Buzzing Noise From LH Side Under Dash

Service Category Vehicle Interior

Section Heating/Air Conditioning

YEAR(S)	MODEL(S)	ADDITIONAL INFORMATION
2016	Prius	WMI(s): JTD VDS(s): KARFU, KBRFU Engine(s): 2ZR Drive Type(s): 2WD Transmission(s): CVT Plant Code(s): 3

Figure 1.

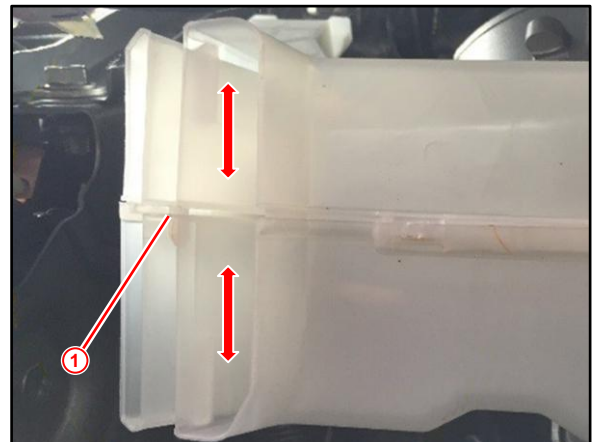
Some 2016 model year Prius vehicles may exhibit a condition where there is a buzzing noise from the LH side under the dash while driving (see Figure 1).

The pin that secures the center section of the HVAC duct together may be loose, making a buzzing noise (see Figure 2).

Follow the Repair Procedure below to address this condition.
